BID ADDENDUM NO. 2

Date of Addendum: January 9, 2024
Issued for Bid Date: December 18, 2022
Client Name: Eastchester Union Free School District
Project Name: 2022 Capital Bond Project, Phase 3
SED Project No.: Anne Hutchinson Elementary School: 66-03-01-03-0-001-023
Eastchester Middle / High School: 66-03-01-03-0-003-031
MEMASI Project No.: 102-2301
Contracts: Contract No. 1 – General Construction (GC)
Contract No. 2 – Mechanical Construction (MC)
Contract No. 3 – Electrical Construction (EC)
Contract No. 4 – Plumbing Construction (PC)

MS-WATER RISER DIAGRAM
SCALE: NTS

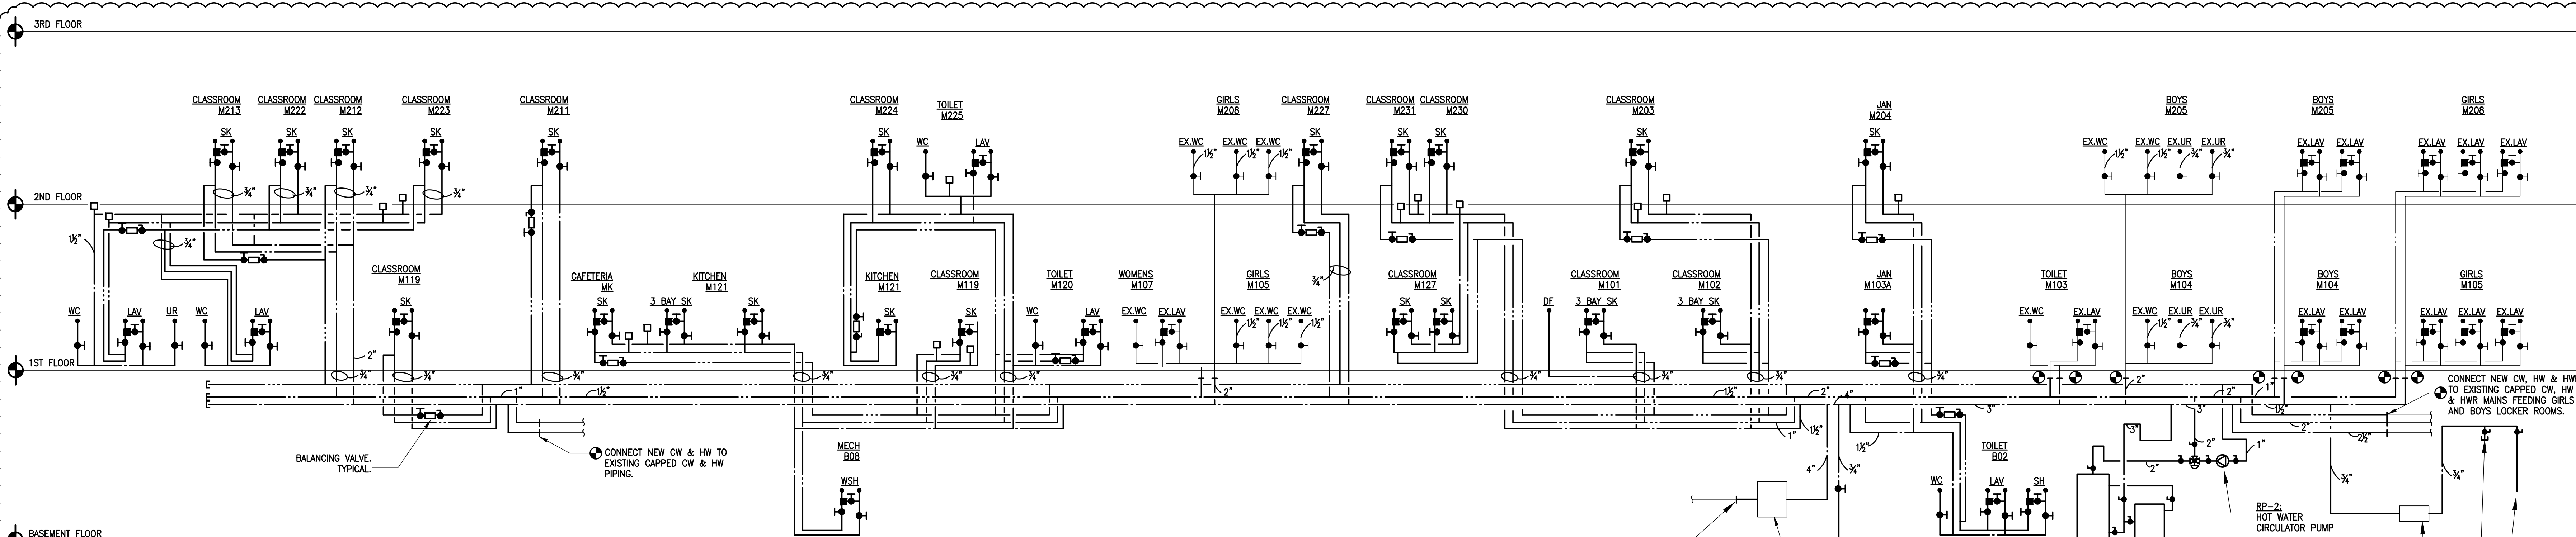
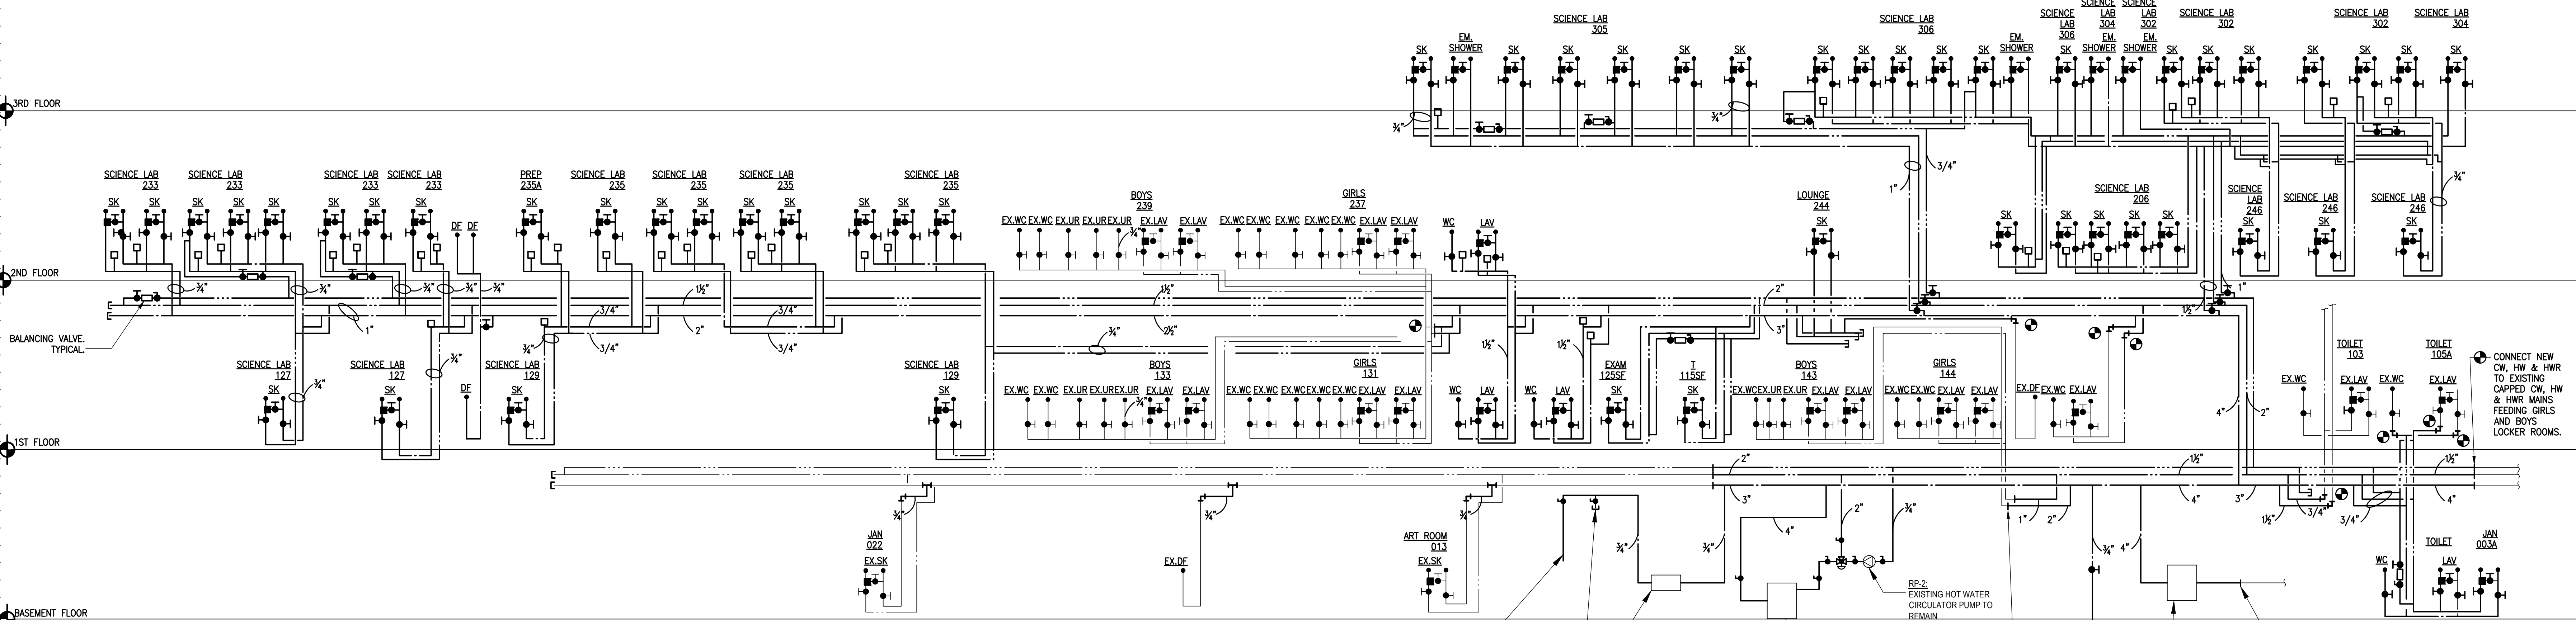
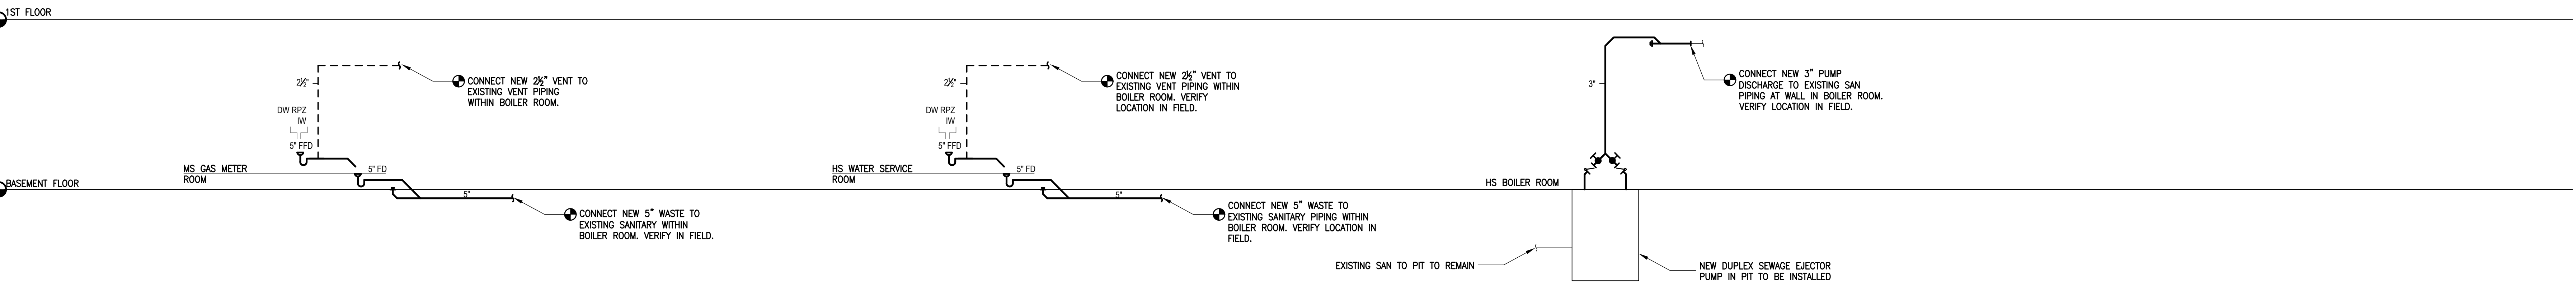
- 15. MSHS P100-A – PLUMBING PART PLAN – BASEMENT – AREA A**
 - a. Added size to new alarm check valve and sprinkler piping.
- 16. MSHS P501 – PLUMBING RISER DIAGRAM**

- a. Revised fixture tags to indicate existing fixtures.
- 17. MSHS P601 – PLUMBING SCHEDULES**
 - a. Updated Water Heater Schedule & Plumbing Fixture Schedule.

The riser diagram on the plumbing drawing P501 does not conform to the other plumbing drawings. For example there are 38 WC, 37 Lavs, and 13 urinals, 4 janitor sinks, 4 emergency showers and 1 shower. These fixtures are not shown on any other plans. Are the fixtures for informational purposes for replacing associated piping? Please advise

These fixtures are existing to remain and shown for reference. The fixture tags have been update to show them as existing, please refer to drawing P-501.
